Access Compliance Report

Public Rights-of-Way

(Curb Ramps)

Intersection ID: 44446	Main Street: REAMES_RD	Cross Street: PRESTBURY_BV	Location: SE
ADA ID: 768B0E217674	Ramp Type: PerpDiag	Initial Pass/Fail: Fail	Overall Compliance: No
Severity Score: 12.5			
Codes/Mitigation Info/Possible Solution		Field Measurements/Component Compliance

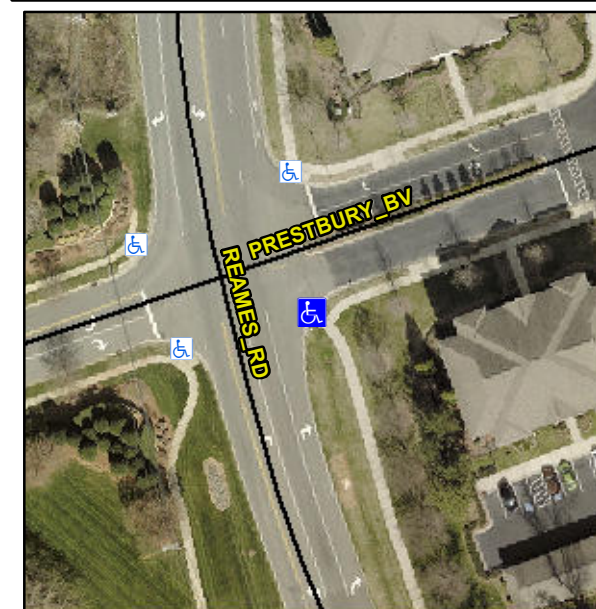
Remove & Replace Curb Ramp With Two New Directional Ramps or Equivalent.

Not Found, R304.5.3

Compliance	Description	Data	Compliance	Description	Data
N/A	Ramp Length (in)	70.0	Yes	Ramp Slope (%)	5.8
Yes	Ramp Width (in)	48.0	No	Ramp XSlope (%)	5.5
N/A	Flare Type LT	N/A	N/A	Flare Type RT	N/A
N/A	Flare Slope LT (%)	N/A	N/A	Flare Slope RT (%)	N/A
N/A	Flare Traversable LT?	N/A	N/A	Flare Traversable RT?	N/A
N/A	Landing Length (in)	N/A	N/A	DWS Provided?	N/A
N/A	Landing Width (in)	N/A	N/A	DWS Contrast?	N/A
N/A	Landing Slope (%)	N/A	N/A	DWS Length (in)	N/A
N/A	Landing X Slope (%)	N/A	N/A	DWS Full Width?	N/A
N/A	Landing Curb? (Y/N)	N/A	N/A	DWS Offset (in)	N/A
N/A	Shared Landing?	N/A			
N/A	Gutter Ponding?	N/A	N/A	Gutter Slope (%)	N/A
N/A	Gutter Lip Ht (in)	N/A	N/A	Gutter X Slope (%)	N/A
N/A	Painted X Walk1?	No	N/A	Painted X Walk2?	No
	X Walk 1 Direction	To N		X Walk 2 Direction	To W
N/A	X Walk 1 Width (in)	N/A	N/A	X Walk 2 Width (in)	N/A
	X Walk 1 Slope (%)	2.5		X Walk 2 Slope (%)	3.8
	X Walk 1 X Slope (%)	4.7		X Walk 2 X Slope (%)	3.9
